ADDENDA #4 to RFP # 19/19/P

Groundwater Monitoring, Soil Vapor Monitoring and Other Environmental and Engineering Services for Landfill Sites

Paseo de Vista Landfill Questions

MONITOR WELL COMPLETION DIAGRAM

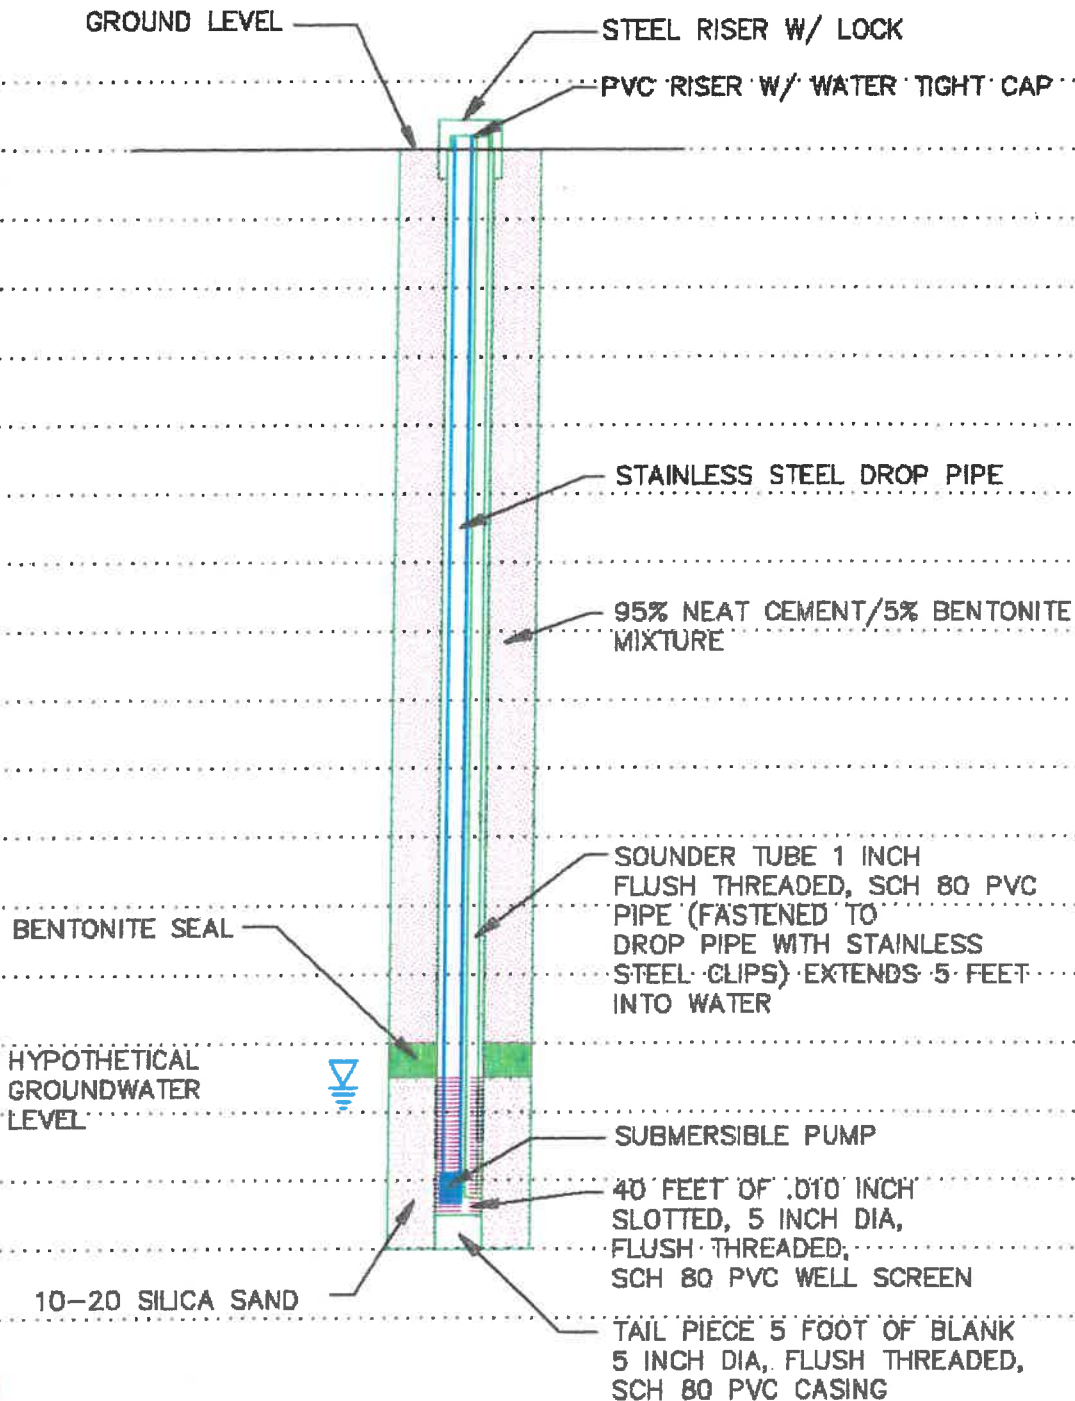
- 2. Is there any information regarding groundwater well construction including total depth, screen interval, well diameter, and depth to water?**

- 3. Is there any information regarding soil vapor well construction including screen intervals, well diameter, and total depth?**

See attachment #4.

See Attachment #4.
